Elephant & Castle to Crystal Palace Quietway (QW7)

New Church Road / Edmund Street junction to Peckham Road

Responses to Consultation Questions

Detailed Consultation Comments and Responses

Elephant & Castle to
Crystal Palace Quietway
Benhill Road

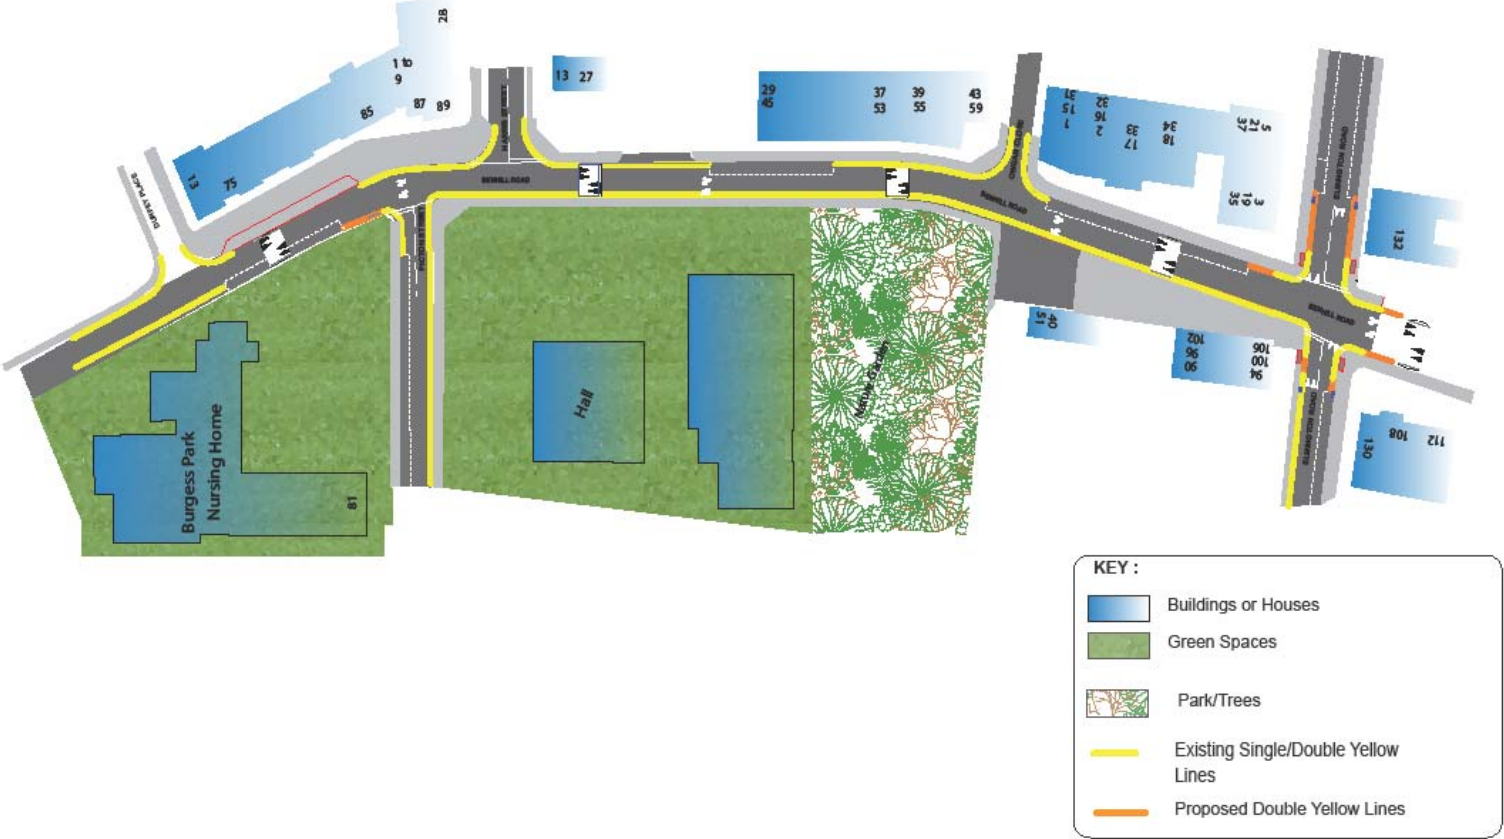
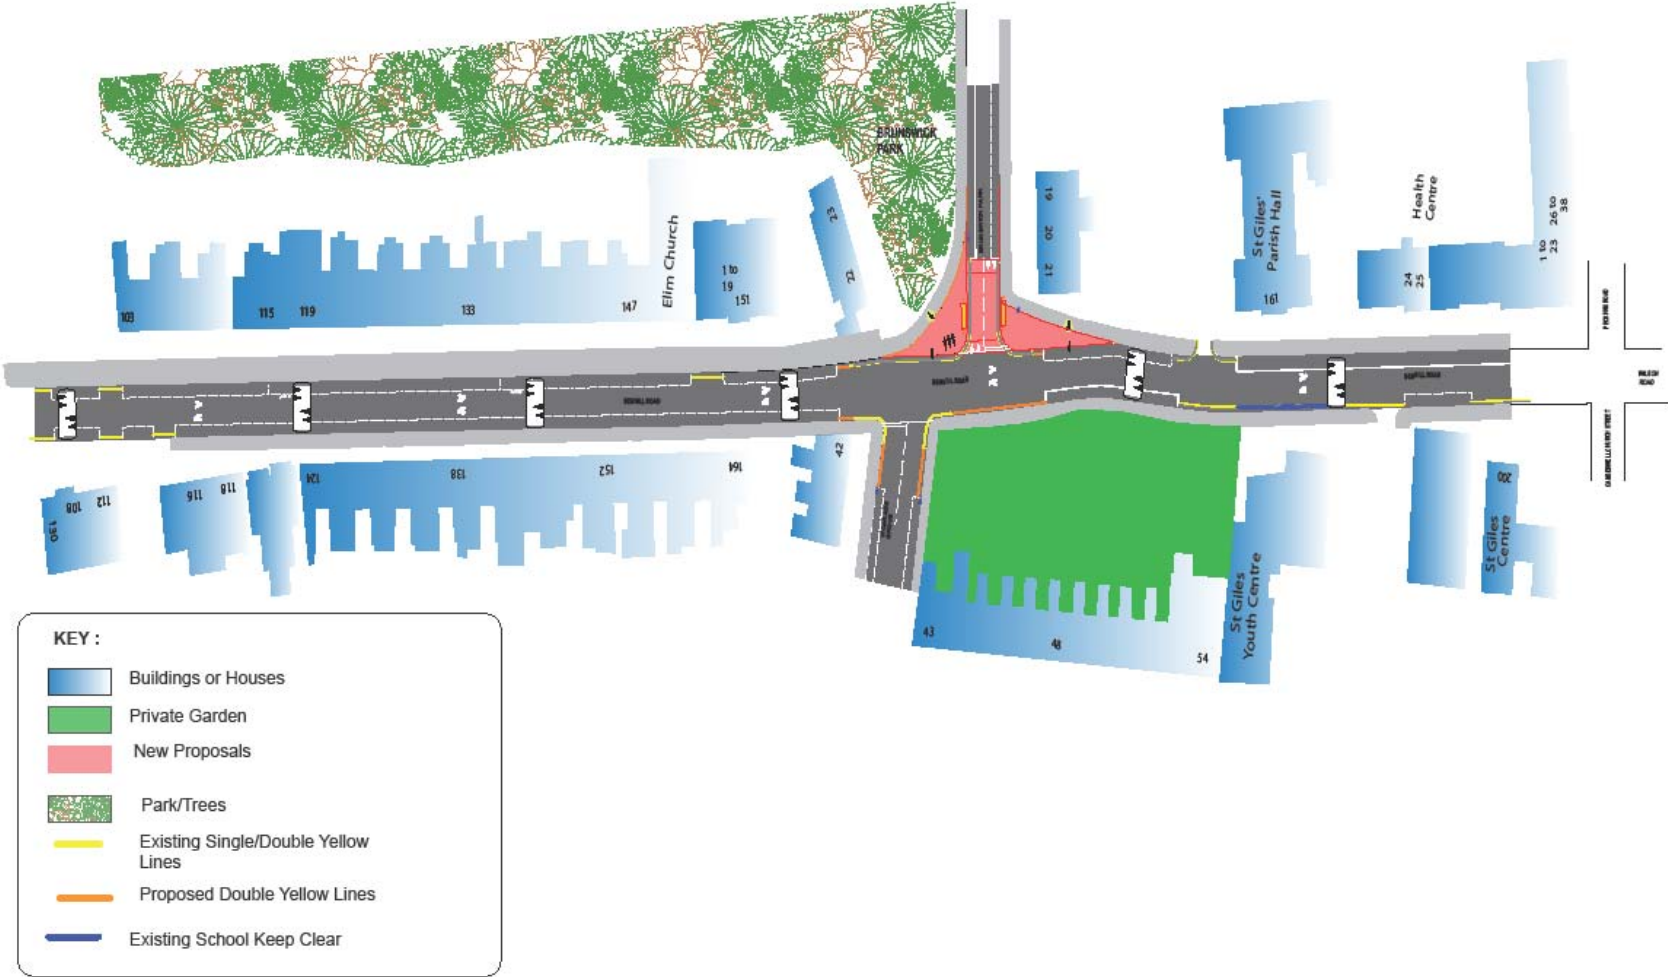
<p>Proposals at Brunswick Park / Benhill Road junction</p>	<p>Adequate visibility is achieved with current junction layout.</p>	<p>Large radius layout raises the likelihood of left turn collision at junction.</p> <p>Visibility is improved with proposed layout.</p>

Reference No.	Support	Comment	Key Considerations (and Responses)
19	No	Specifically, there is no need at all for changes at the Benhill Rd/Brunswick Park junction as there is ample room and visibility already. Elmington Rd/Benhill Rd could be improved as people do park too close to the junction for good visibility.	Large radius layout raises the likelihood of left turn collision at junction. Visibility is improved with the proposed layout.
29	Yes	The Brunswick Park junction should be tightened further with buildouts outside the junction, as on Portland Street. Less confident/slower cyclists should not have to pull out from parked cars where there is a long gap between bays: instead the gaps between car parking should be built out.	None
